Docket Item # 4  
BAR CASE #2008-0064

BAR Meeting  
May 21, 2008

**ISSUE:** Alterations  
**APPLICANT:** Kathleen Thompson  
**LOCATION:** 316 South Alfred Street  
**ZONE:** RM/Residential

Figure 3. Specifications for proposed steps, landing and railing.

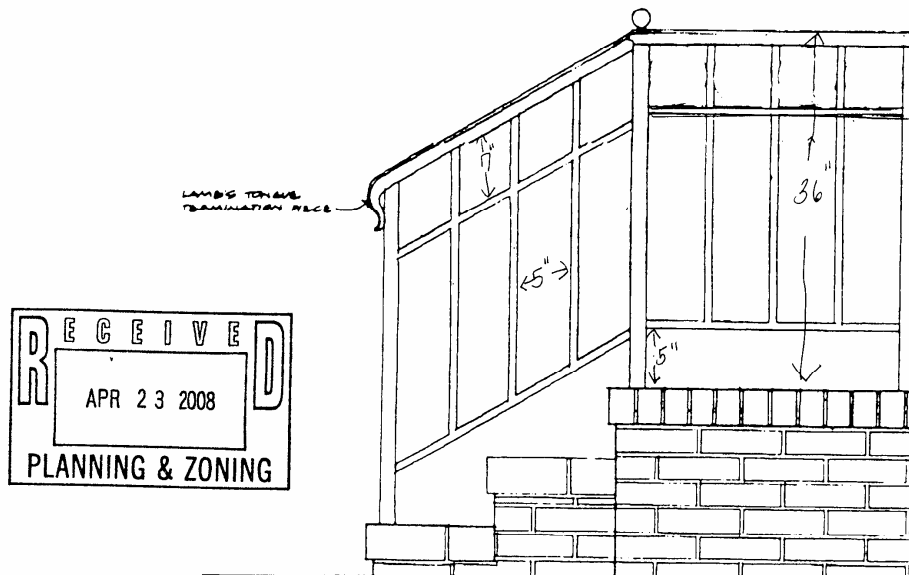
- C-5 The new stairs must comply with USBC for riser and tread dimensions.
- C-6 Guardrails and intermediate rails must comply with USBC 1012.1.
- C-7 The new handrails must comply with USBC for a minimum/maximum height of 30 to 34 inches. The ends must extend 12" beyond the top and bottom risers. The handgrip position must not be more that 2-1/4" in cross-sectional dimension, or the shape must provide an equivalent gripping surface. The handgrip portion must have a smooth surface with no sharp corners. The space between the wall and handrail must not be less that 1-1/2".
